Hill Road Upgrade

Addendum review of environmental factors

October 2025

Figure 1-2: The proposed modification (adjacent to the M4 on-ramp)
NB. Tree number 109 is no longer present and was removed in accordance with a separate environmental assessment.

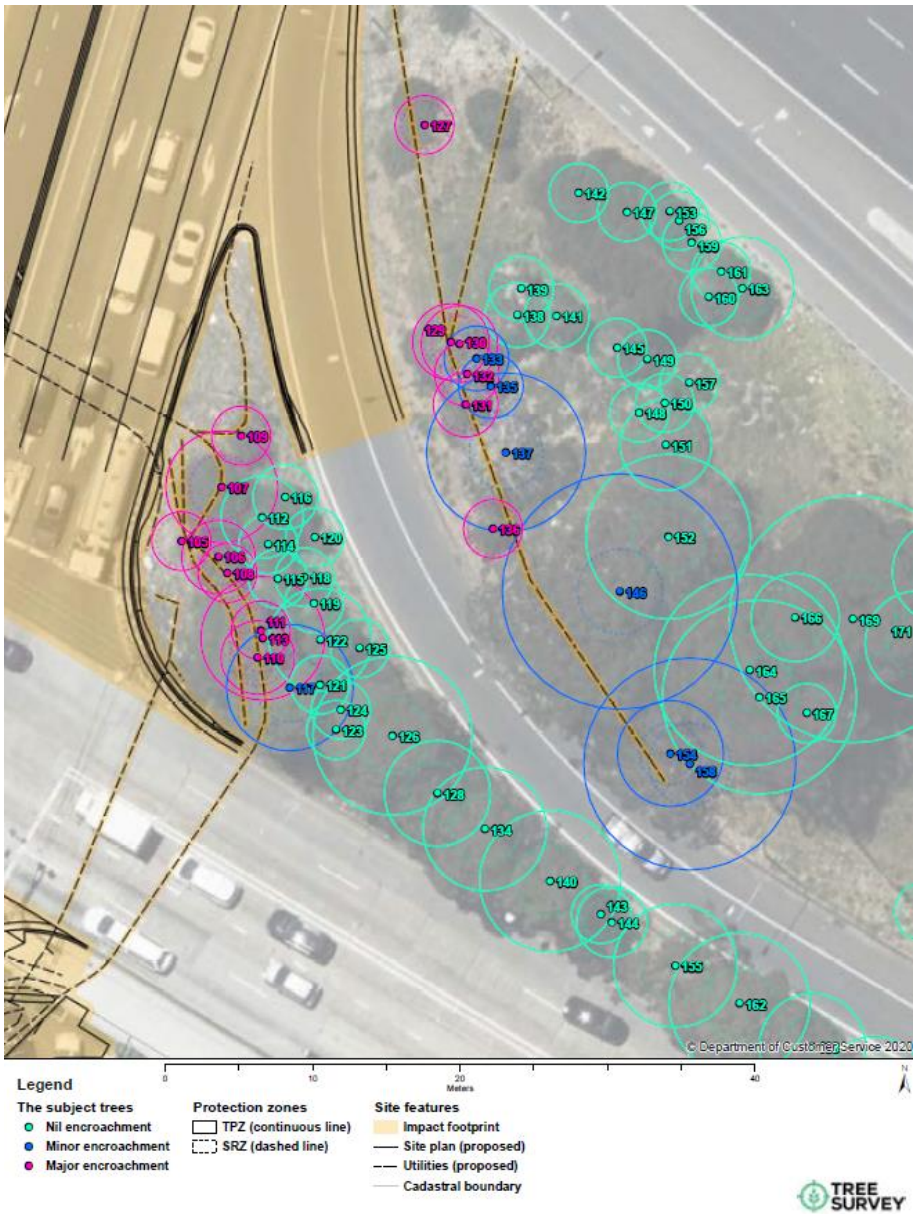
The modification would require removal of 0.07 ha of vegetation located within the traffic islands at the north-eastern corner of the Parramatta Road and Hill Road intersection, as well as adjacent to the M4 on-ramp.

The location of the proposed modification is shown in Figure 1-1, and the proposed modification is shown in Figure 1-2. Section 3 describes the proposed modification in more detail.

Figure 3-2 Eastern portion of Stand of *Eucalyptus longifolia* (I188) showing trees removed and retained
NB. Tree number is no longer present and was removed in accordance with a separate environmental assessment.

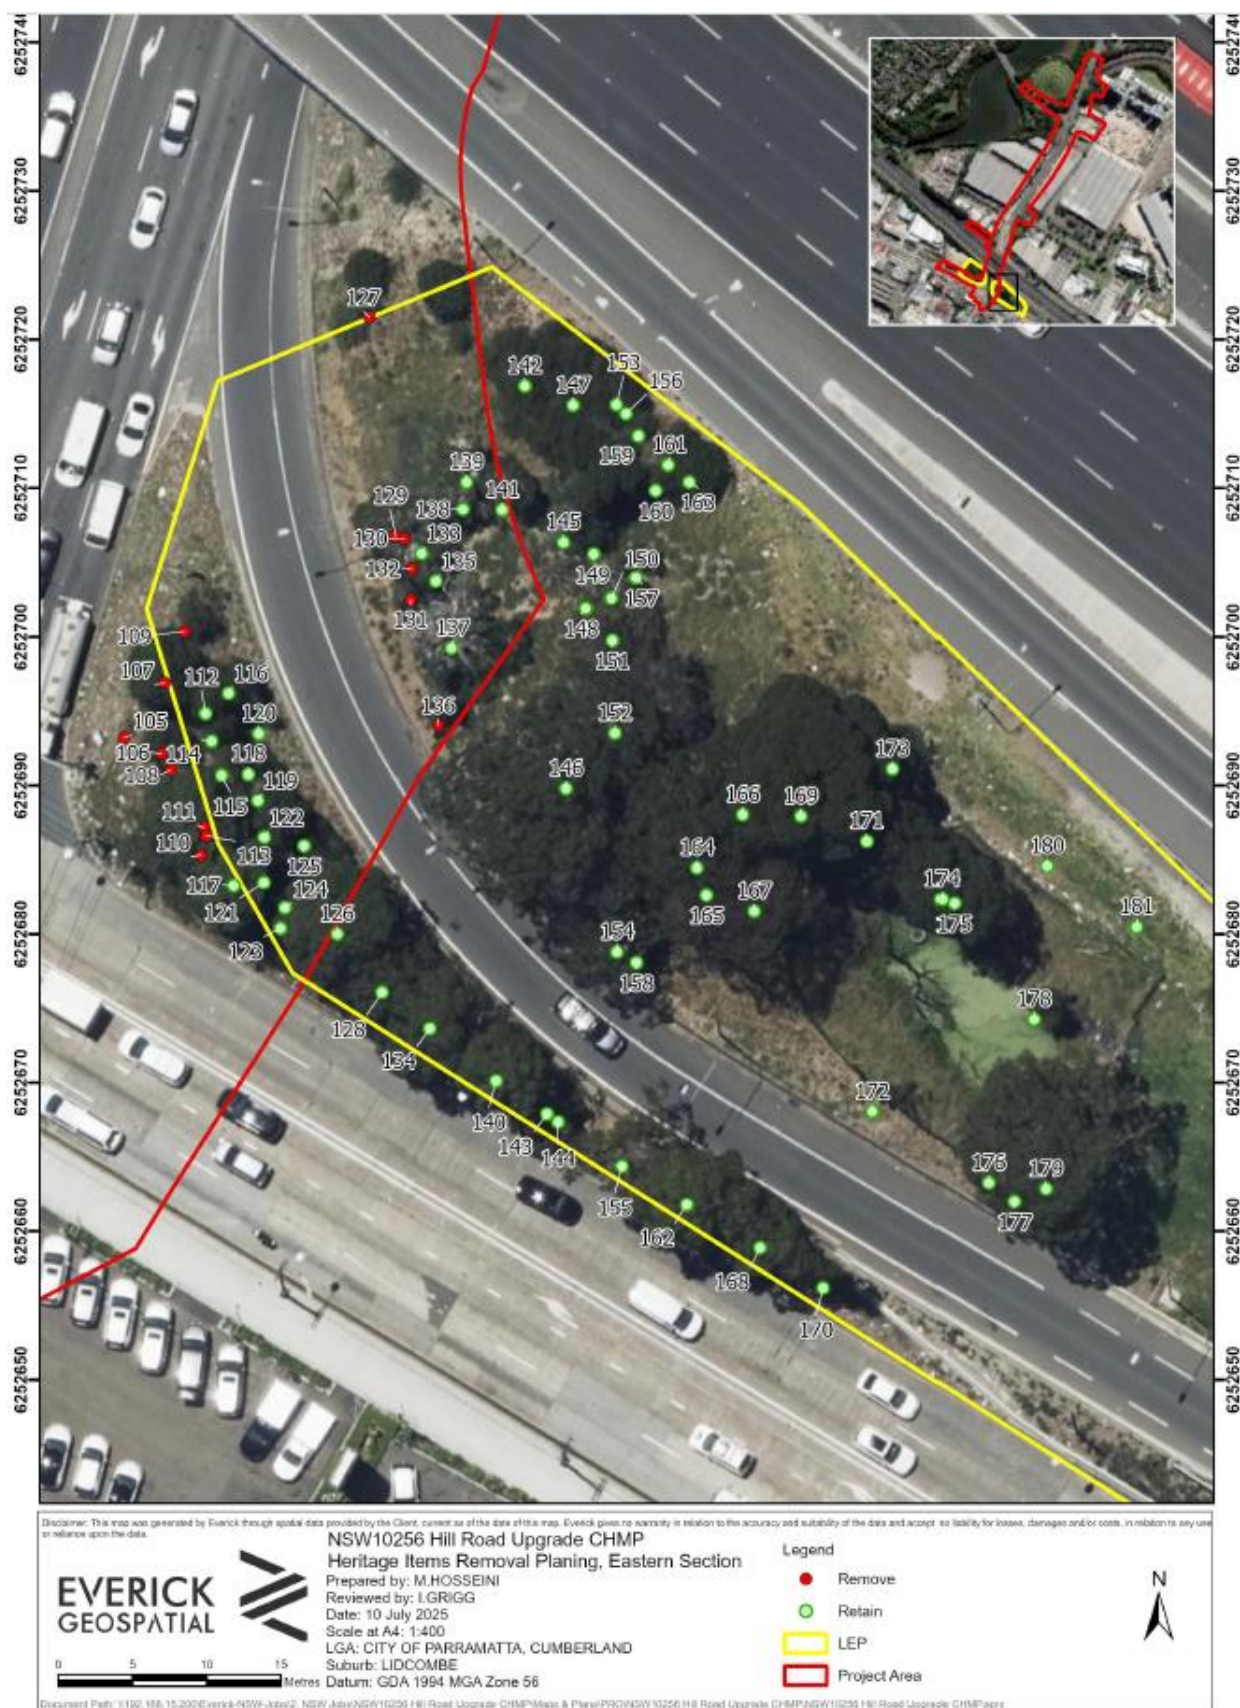
As a consequence of this design modification, there would be additional impact to vegetation. An additional 0.07 hectares of vegetation would be removed, on top of the 0.67 hectares already assessed in the Review of Environmental Factors (REF). This 0.07ha includes 13 trees (as shown in Figure 1-2 and described in Table 3-1) which would suffer major encroachment (more than 10%) into the Tree Protection Zones (TPZs). Field-validated vegetation mapping shown in Figure 3-1 identifies that the majority of the increased footprint area (0.06ha out of the 0.07ha) is mapped as Castlereagh Ironbark Forest (PCT-3448) which conforms to the Endangered Shale Gravel Transition Forest in the Sydney Basin Bioregion listed as Endangered under the EPBC Act.

The impacted vegetation also falls within the curtilage of a locally listed heritage area (Item I188 - "Stand of *Eucalyptus longifolia*" (Sydney Red Gum) within the Cumberland Council Local Environmental Plan) shown in Figure 3-2 .
